Fort Lauderdale Police Headquarters

WJE Peer Review, Phase 2 – Building Structural Design Peer Review

Draft Report

April 22, 2025
WJE No. 2024.4855.0

Figure 3. Image from the file "2025311_FLP Column H-2 and J-2 Validation.pdf" (dated March 11, 2025) prepared by the SEOR which indicates that they used a flexural stiffness modifier of 0.35 for reinforced concrete columns along Gridline 2

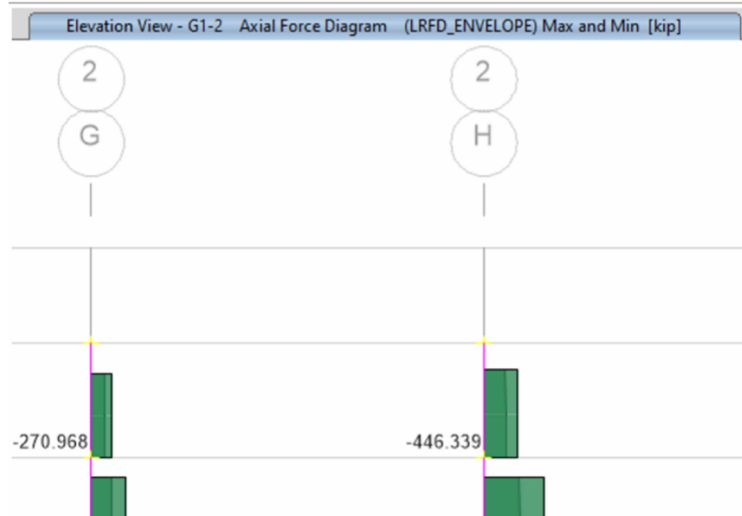
In their response, the SEOR concluded that “Micro-cracking at the spandrel-column interface will relieve nearly all of the bending moment at the column tops at Columns G/2 & K/2, and thus the shear calculated by WJE will not enter the columns at all.” To justify this conclusion, the SEOR approximated the flexural moment that would result in cracking of the columns, considering the tensile capacity of concrete and the compressive axial loading in the columns from gravity loading. The SEOR further noted that, based on WJE’s calculations of the negative moment capacity of the composite joist and slab, the cracking resistance of the columns was expected to be surpassed and therefore, the columns would crack. Continuing, the SEOR claimed that “This is normal behavior in a structural floor system of this nature. The introduction of a very small flexural crack at the top and bottom of the column will cause the traditional pin-ended column behavior that is commonly assumed for this type of floor system.” While we disagree with the SEOR that, once a reinforced concrete column cracks, it devolves into a pin-ended condition that no longer resists flexure at the cracked location, we understand this statement as indicating that the SEOR designed the FLPHQ by assuming that the columns have pinned ends. In other words, the columns had an effective flexural stiffness modifier of 0.00.

During our meetings with the SEOR, we also conveyed that we believed that the other columns on Gridline 2 (at the intersections of Gridlines H and J) required minimum transverse reinforcement due to the shear demand in the existing 16 inch by 16 inch columns. In their calculations package in response to our concern (dated March 11, 2025), the SEOR contended that, based on their numerical model, the columns had sufficient shear capacity such that Section 10.6.2.1 of ACI 318-14 did not require minimum transverse reinforcement for those columns. The SEOR provided column loads from their model (Figure 3) that were predicated on the use of a column flexural stiffness modifier of 0.35 to determine the loads. Using these demands, the SEOR calculated the nominal concrete shear strength using Equations 22.5.6.1(a–b). Since the bending moments in the columns were sufficiently small, Equation 22.5.6.1(b) was permitted to be used in lieu of Equation 22.5.6.1(a), the latter of which results in a lower calculated shear strength. Using Equation 22.5.6.1(b), the SEOR concluded that minimum transverse reinforcement was not required, based on Section 10.6.2.1 of ACI 318-14. While we still disagreed with the SEOR, we understand this calculation package as indicating that the SEOR designed the FLPHQ using a column flexural stiffness modifier of 0.35. This assumption is internally inconsistent with their previous claim that the members exhibit “pin-ended column behavior.”

Figure 4. Detail 7 from Sheet HQ-S7-1-02 which shows CMU wall bearing on thickened slab-on-ground. Note that there is a vapor retarder under the slab-on-ground supporting the partition masonry walls

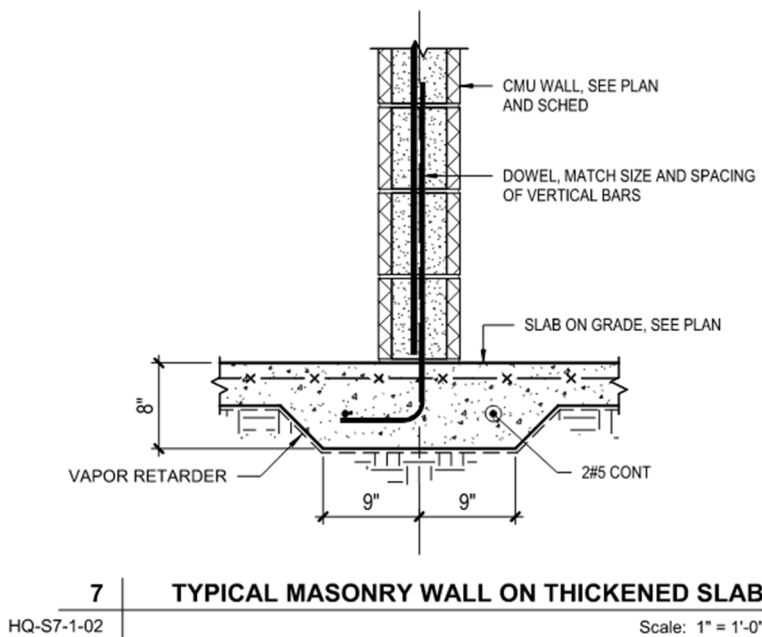
- On numerous sheets in the structural drawings (e.g., Sheet HQ-S2-2-1A), the CMU partition walls are referred to as “non-loadbearing CMU” which bear on thickened slab built over a vapor retarder (Detail 7 of Sheet HQ-S7-1-02). A vapor retarder would reduce the sliding resistance of the wall.

- **Masonry Wall Connection Details at Top and Bottom of Wall.** Both 7/HQ-S7-1-02 (Figure 4) and 2/HQ-S6-1-01 (Figure 5) indicate that the vertical reinforcement at the bottom of the CMU walls should be lapped with dowels. These dowels were to extend into the footing, or thickened slab, and be hooked. At the top of the CMU walls, two details are provided on Sheet HQ-S7-1-02, which is labeled as “Typical Masonry Details”. Detail 3/HQ-S7-1-02 appears to be a detail for use with CMU walls that are bearing walls. A note in this detail also indicates that this detail applies when tie-beams are referenced on plan. We did not observe any tie beam references on plan, and we also did not observe on the plans where any CMU walls were explicitly designated as bearing walls. As such, Detail 3/HQ-S7-1-02 appears to not be applicable to the interior masonry walls. A wall schedule shown on HQ-S6-1-01 (see Figure 6) also does not explicitly designate any of the CMU walls as bearing walls. The masonry shaft noted above would necessarily be a bearing wall as it supports the end of concrete joists, but all other walls (not within Area E) appear to be non-loadbearing walls and in fact are believed to have been constructed as infill after the concrete structure was built. Detail 6/HQ-S7-1-02 (Figure 7) is further divided into two details, a typical detail that applies to both interior and exterior walls and an alternate option that applies to interior walls only. The typical detail shows the vertical reinforcement of the CMU wall embedded into the slab above. No minimum embedment depth is provided, but the details note that the slab thickness must be a minimum of 4 ¾ inches. Section 042200 of the specifications, “Concrete Masonry Units” Part 2.6.C addresses “Top of Wall Anchors.” This specification section is shown in Figure 8. Interior non-load bearing partition walls in Seismic Design Category A, which applies to the FLPHQ, are shown to allow PTA series anchors by either Blok-Lok or by Hohmann & Barnard (H&B). A specification sheet for PTA 420 HS anchors by H&B is shown in Figure 9. A lateral load capacity for the anchor is not provided on this sheet nor is the type of fastener (e.g., screws) required to connect the anchor to the concrete structure above. It may be that this information exists somewhere else on H&B’s website, but we could not find it. As such, it is unclear to us if these anchors are approved or rated for lateral load transfer, and if so, what load they are rated for. Also unclear is the capacity that the SEOR assumed for these anchors. A rendering of the PTA 420 HS anchor at the top of a CMU wall (also taken from H&B’s website) is shown in Figure 10. Note that the anchor is shown with the length of the top plate oriented transverse to the length of the wall, suggesting that its rated capacity would be applicable to out-of-plane rather than in-plane loading.

- **Report No. 087, Dated January 8, 2024:** The TI notes that "SOG pour 4 rebar. Dowels for CMU wall need to be rearranged [sic] so that the compy [sic] with detail 7/HQ-S7-1-02 for typical masonry wall on thickened slab." The TI also notes: "On CMU wall on lvl 1 area A grid line 4, rebar needs to be extended to the bottom of lvl 2 slab. See image on next page." See photographs from the report in Figure 19.

- **Report No. 107, Dated February 8, 2024:** The TI notes that “Partial inspection of slab rebar for SOG pour 5. Dowels for CMU need to be lowered to comply with what is specified on detail 7/HQ-S7-1-02.” Figure 24 shows a photograph of this condition and a photograph of a CMU wall under construction. Again, note that no shoring of the structure above is present, indicating that the CMU wall was not constructed as a bearing wall.

Figure 5. Detail 2 from Sheet HQ-S6-1-03 which shows CMU wall foundation for wall footings that have WF# designation on the foundation plans. Note that the vapor retarder under the slab-on-ground does not pass under the wall footing

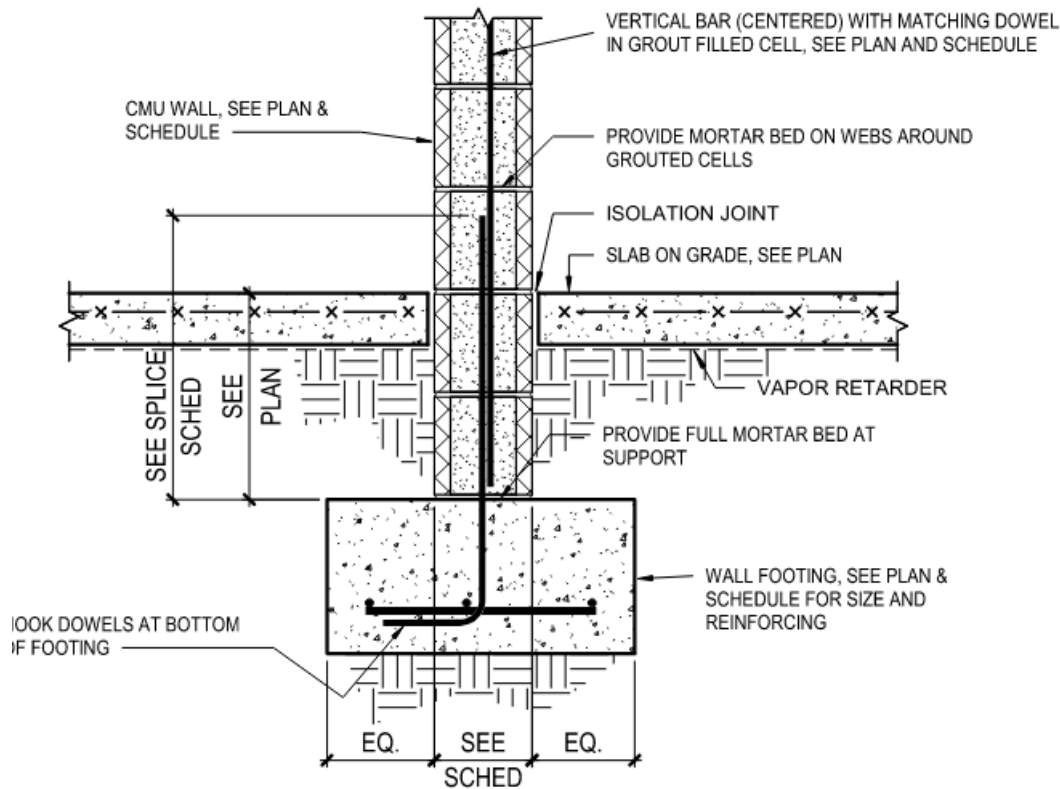
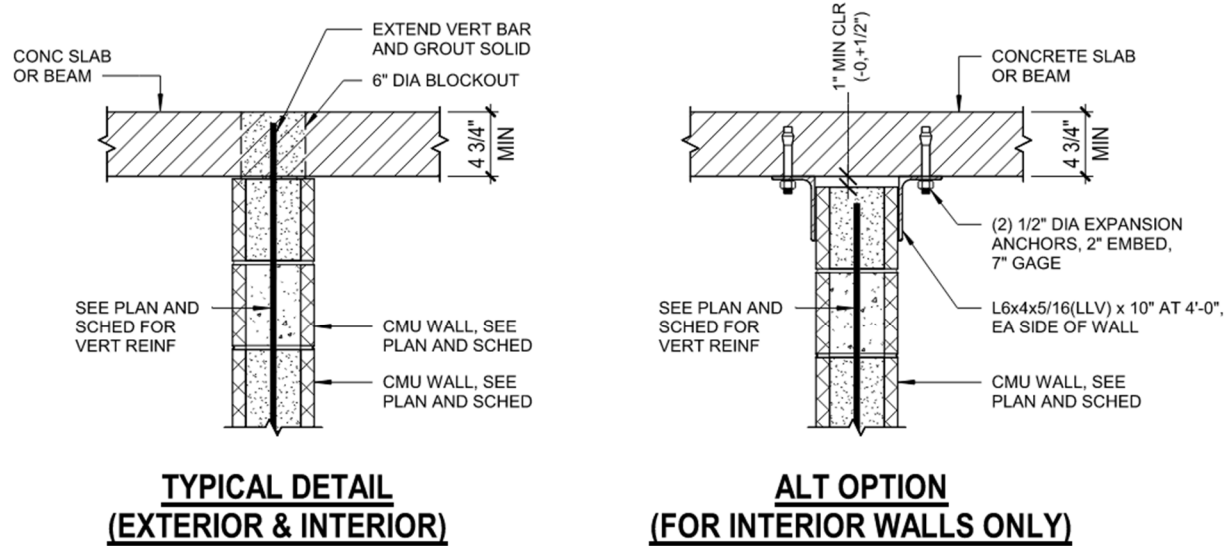
Furthermore, it is evident that the SEOR is aware of what good practices are for designing masonry shear walls, evidenced by the east-to-west spanning wall used in Area E. Unlike the partition masonry walls, that wall a) was constructed such that axial and diaphragm loads from the roof can be transferred to the wall (Figure 23), b) has vertical reinforcement that is well-anchored to develop shear-friction resistance (Figure 11), and c) has a standalone wall footing without a vapor retarder underneath it, thereby increasing the sliding resistance of the wall (Figure 5).

Figure 17. Photographs from Threshold Inspection Report No. 081. Left photograph shows overall wall construction on first story at one location. Right photograph shows the PTA anchors at the top of the wall. Note that two screws are used to connect each anchor to the above element

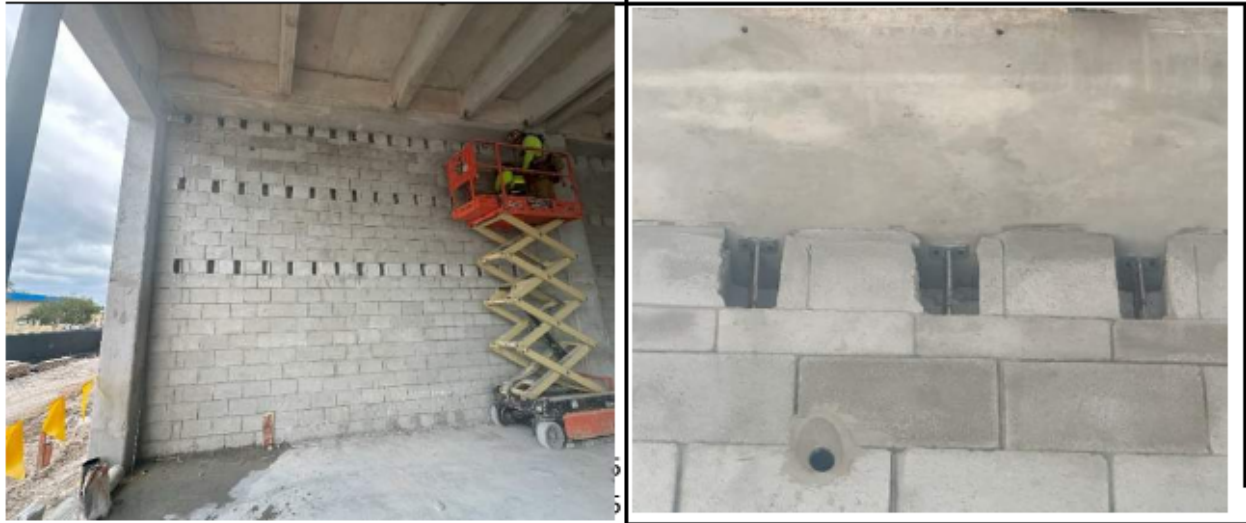
- **Report No. 081, Dated December 19, 2023:** Comments by the TI are in regard to the concrete used in slab-on-ground Pour 3. However, photographs of CMU walls in the first story are also shown in the report (Figure 17). These photographs show the overall CMU wall construction at one location in the first story and the approved PTA anchors at the top of the wall. The length of plate at the top of the PTA anchors is aligned parallel with the length of the CMU wall in contrast with the rendering shown on the manufacturer's website (Figure 10).

Figure 18. Photographs from Threshold Inspection Report No. 084. Upper photographs and lower right photograph appear to be of the first story prior to full installation of CMU walls. Note the lack of shoring indicating that the CMU walls were not constructed as bearing walls

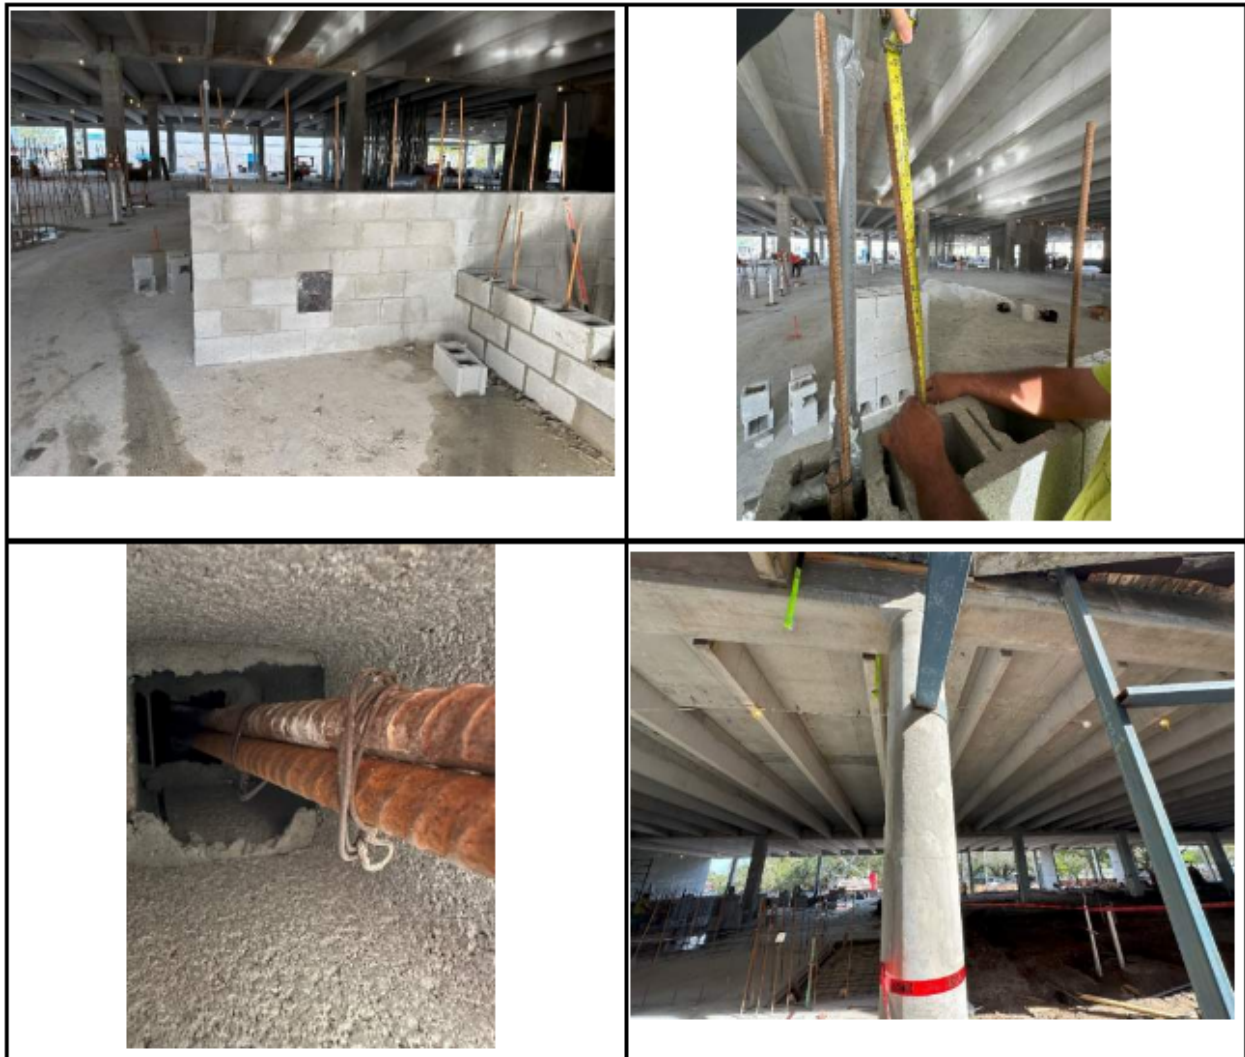
- **Report No. 084, Dated January 2, 2024:** The contents of this report are not in regard to CMU wall construction, but the included photographs (Figure 18) appear to show the first story with vertical reinforcement extending upward from the slab-on-ground, but prior to the CMU walls being fully installed. No shoring of the structure above is present, indicating that the CMU walls were not constructed as bearing walls.

Figure 31. Cross-section of soffit beam (Sheet SC-3C-D of Submittal 328) showing 1.5 inches of cover to the transverse reinforcement

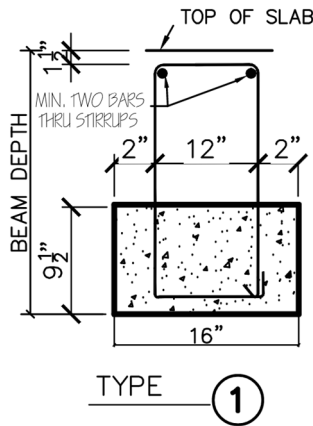
- **Durability.** The cover depths shown in the structural drawings satisfy code-prescribed minimum values. However, the dimension lines shown in the precast concrete shop drawings (e.g., Sheet SC-3C-D of Submittal 328) were inconsistent and implied different cover depths. Figure 31 and Figure 32 illustrate one example of this inconsistency. For the first detail (Figure 31), the 1.5-inch dimension was drawn from the top of slab to the transverse reinforcement. For the second detail (Figure 32), it was drawn from the top of slab to the center of the top longitudinal reinforcement such that there was approximately zero inches of cover to the transverse reinforcement. We are unable to ascertain if what was constructed conforms to the cover requirements set forth in Figure 31 or Figure 32.

Figure 35. Sectional view of a reinforced concrete column which is enlarged to increase resistance. Note that the new transverse reinforcement should be spaced closely to provide confinement

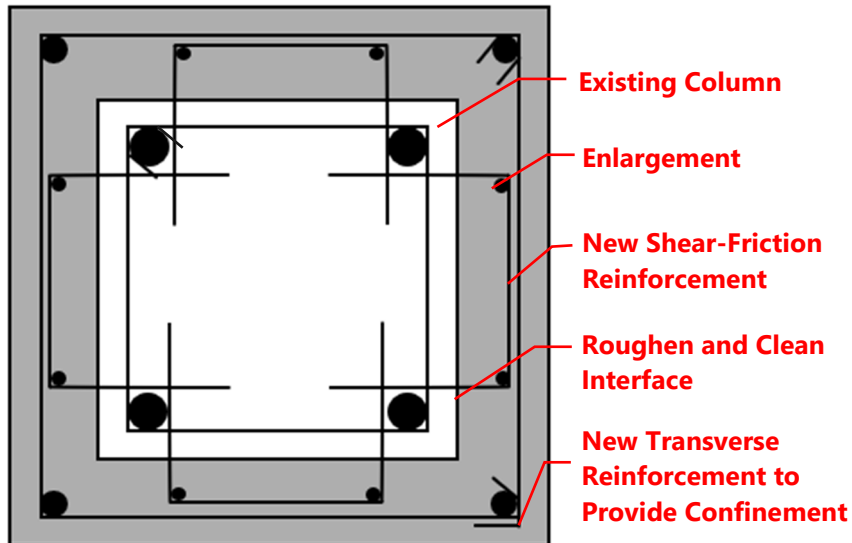
The cross section of the column can be enlarged to strengthen the column for both combined axial and flexural loading and for shear. Figure 35 conceptually illustrates the enlargement of a reinforced concrete column. Since it will be difficult to anchor new flexural reinforcement at the top and bottom of the columns due to the presence of potentially conflicting reinforcement in the soffit beams, the flexural strength of the column can be enhanced primarily by increasing the effective depth of the section rather than by adding flexural reinforcing steel.

Enlarging the cross section as shown in Figure 35 provides an added benefit of confining the concrete in the original column. When concrete is confined it has a greater strain capacity, thereby increasing the strength and ductility of the column, even without additional anchored vertical reinforcement.

In the column enlargement rectification shown in Figure 35, the perimeter of the existing column is roughened and cleaned to allow for composite action with the enlargement. New shear-friction reinforcement is post-installed into the existing column to enhance interface shear strength between the original column and the enlargement. For columns that are overstressed in axial-flexural loading, the new transverse reinforcement should be spaced closely to provide confinement. For other columns, the new transverse reinforcement need only be spaced more closely than one-half the effective depth of the column. We expect that using No. 4 reinforcing bar ties at this spacing will meet the minimum shear reinforcement provisions in ACI 318-14.

Figure 36. Sectional view of a reinforced concrete column which is wrapped with FRP to enhance shear strength and member deformability

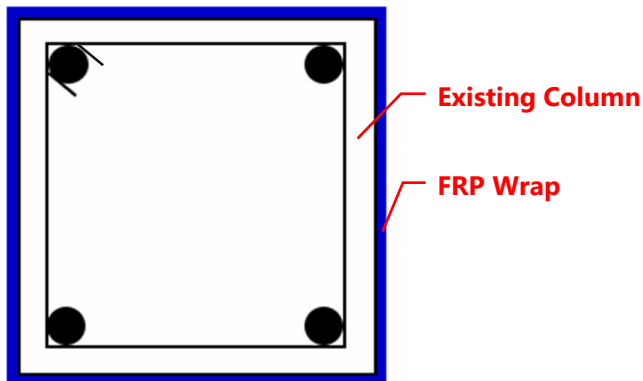
Fiber-reinforced polymer (FRP) jacketing of the columns may also be a viable option to rectify the axial-flexural and shear conditions previously identified. As illustrated in Figure 36, this rectification entails wrapping a column with FRP and adhering it using epoxy. FRP jacketing can be used to provide

Figure 37. Section view of a reinforced concrete beam which is enlarged to increase flexural resistance

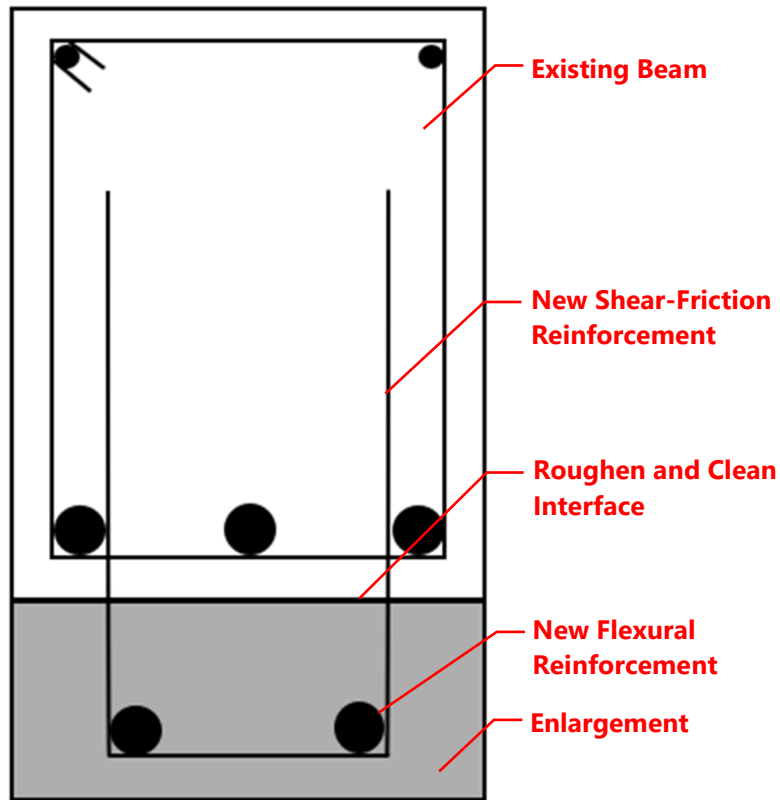
Enlarging the overstressed beams can enhance their flexural strength, similar to the upturned beams on roof soffit beams RSB 76 and 79. A conceptual illustration of this type of rectification is shown in Figure 37. The tension-face of the existing beam is roughened to allow for sufficient interface-shear strength with the new enlargement. Post-installed U-shaped ties embedded (at least one development length on either side of the interface) are provided to enhance interface-shear strength. Adequately anchored tension reinforcement is provided in the enlargement to increase flexural resistance of the beam.

Figure 38. Section view of a reinforced concrete beam showing strengthening with near-surface mounted reinforcement (adapted from ACI 440.2-23)

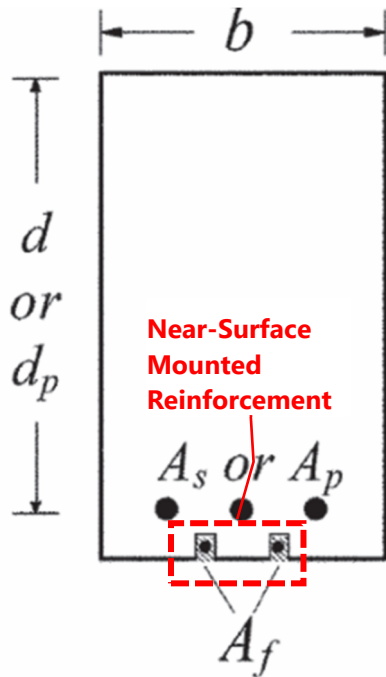
Similar to beam enlargements, a near-surface mounted (NSM) rectification entails providing new longitudinal tension reinforcement to increase the flexural strength of the overstressed beams. As shown in Figure 38, grooves are cut into the existing beam to receive the new reinforcement. The substrate within the groove should be properly prepared to enhance bond strength with new epoxy or cementitious paste which is placed in the groove with the reinforcement. Steel reinforcement may be used, although non-metallic reinforcement or corrosion-resistant metals may be preferable to mitigate the risk of corrosion.

Figure 39. Section view of a reinforced concrete beam strengthened with an externally bonded FRP laminate (adapted from ACI 440.2-23)

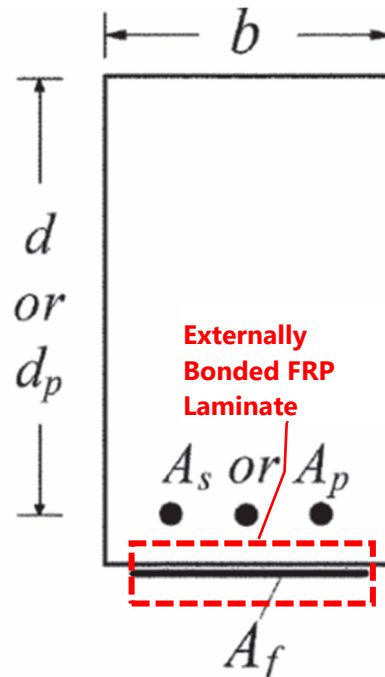
Other externally bonded systems may be utilized to increase the flexural resistance of a beam. ACI 440.2-23 also provides guidance for designing other external FRP systems, such as bonded laminates (Figure 39). Otherwise, a steel plate may be bonded to the beam but would likely require fireproofing. No matter the system used, sufficient anchorage of the external system should be provided such that it may develop its intended strength at the critical regions requiring strengthening.

Figure 41. Conceptual rectification of sliding deficiency of mat footing CF-1. The mat footing is attached to nearby isolated footings (J3, K3, and K4) with new reinforced concrete (shown in blue font)

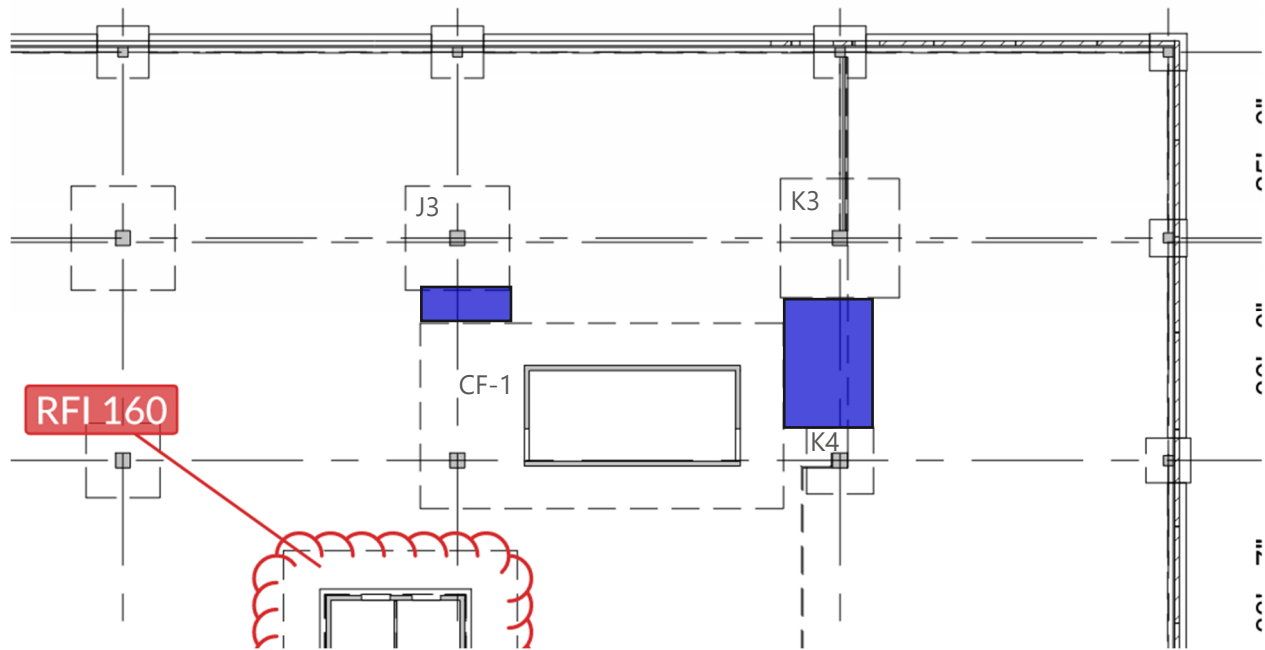
The addition of a shear wall at the location recommended in Figure 40 will not fully rectify the sliding deficiency of mat footing CF-1 (under the north stair shaft). One way of enhancing the sliding resistance of this footing is to connect or tie it to adjacent column spread footings, as illustrated in Figure 41. If CF-1 is connected to the column spread footings at Grid Points J/3, K/3, and K/4, the additional gravity load on these columns will provide additional frictional resistance against sliding resistance for the combined foundations. To connect the footings, new segments of reinforced concrete foundations can be cast. These new tie footings sections should have sufficient strength to transfer the lateral sliding loads from the mat footing and column spread footings. The new tie footings would also need to be reinforced to preclude other limit states such as (e.g.,) one-way shear.
